# PREVOST

## WARRANTY BULLETIN

**WB14-03**

DATE :	APRIL 2014	SECTION :	06 - Electrical
EXPIRATION:	APRIL 2016		
SUBJECT :	BATTERIES BOX COVER REPLACEMENT

Fig.4 Correctly positioned drilling template shown on the left.

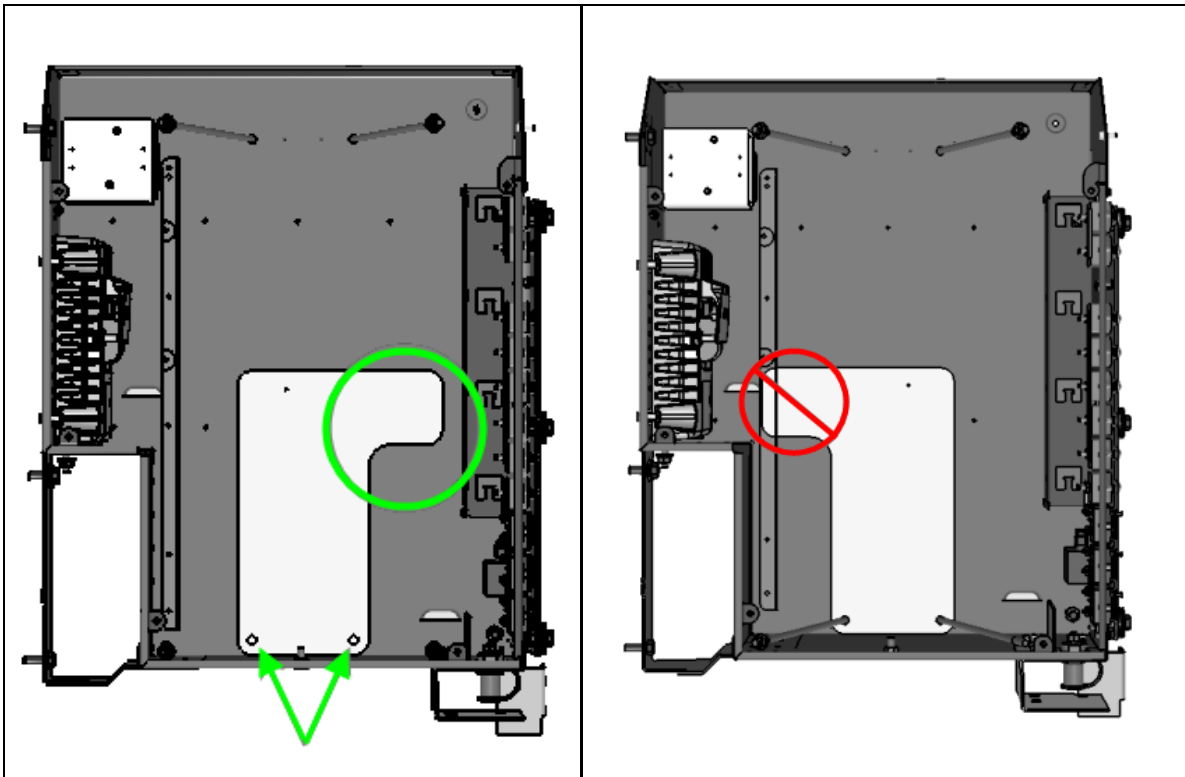
- Position the drilling template at the bottom of the battery box using the hold-down rods holes (Fig.4).

**NOTE: The drilling template is designed with a foolproof tab and can not be installed backward.**

Fig.5 Drilling position viewed from top (Left) and bottom (Right) of the vehicle.

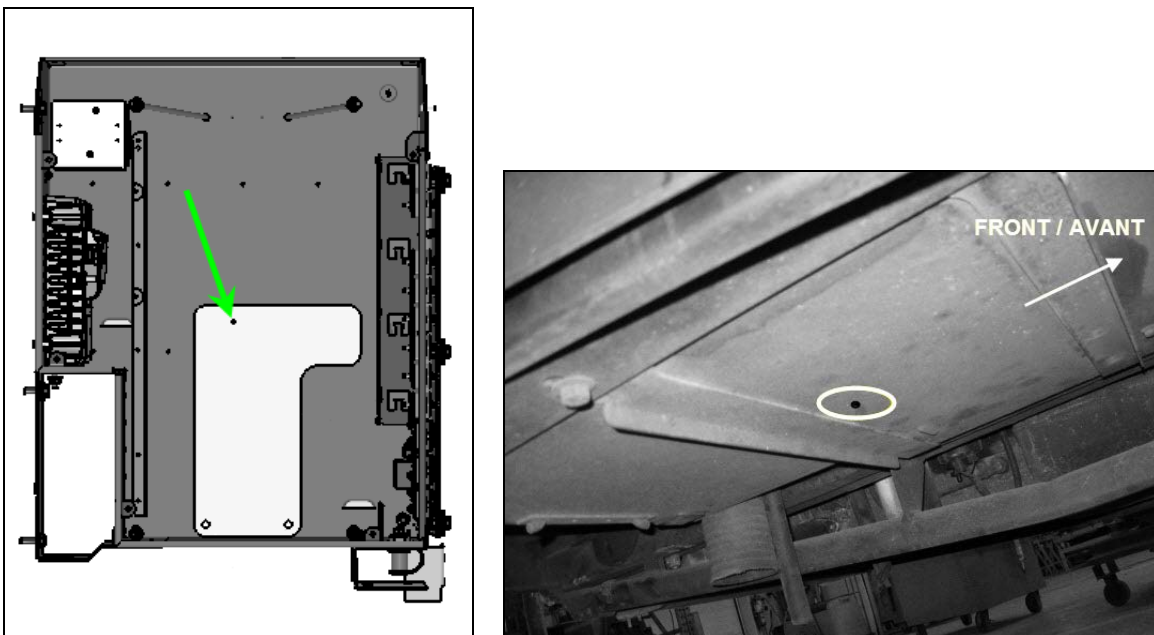
- With the drilling template installed, drill through the box bottom using a 3/8po or 10mm drill bit (Fig.5).

**Fig.6 Battery box cover rod correct positioning.**

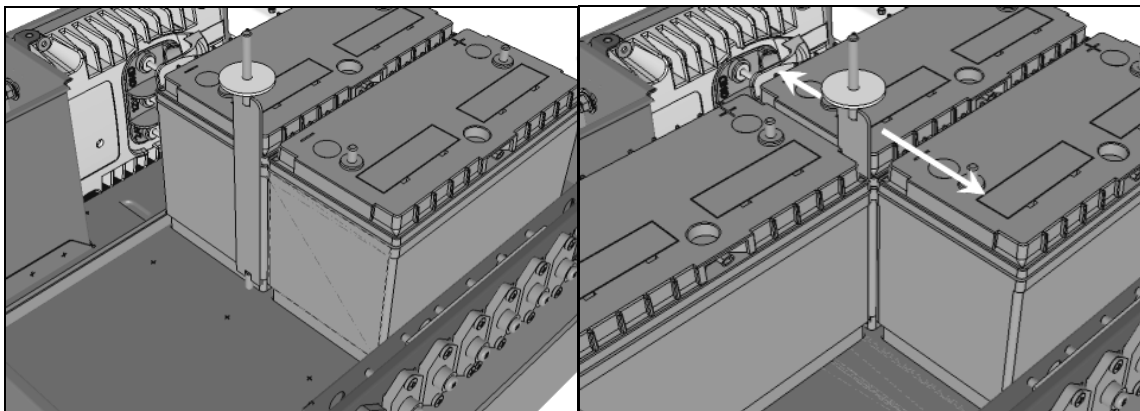
8. Remove the drilling template.
9. Install the new battery box cover rod (068867) at the bottom of the box. From the vehicle underside, hand tight the rod using the supplied 3-8-16 hex nut (500702) and the flat washer (068704).

**NOTE: The rod flat section must be positioned along the width of the box (Fig.6)**

10. With the rod correctly positioned, torque down the 3/8-16 hex nut to 30 ft-lb (40 Nm).
11. Reinstall the four (4) bars hold-down rods (Fig.3).
12. Reinstall the batteries following Fig.7 below.

**Fig.9 New cover installed**

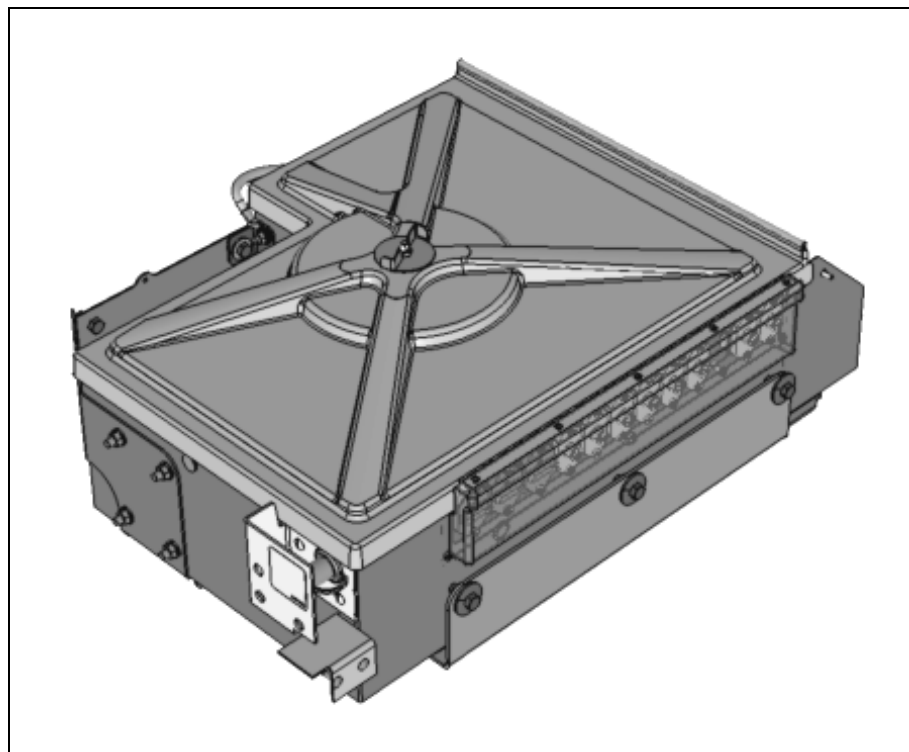
15. Install and tighten the new battery box cover (068858) using the provided wing nut (068765), check for proper fitting of the assembly (Fig.9).
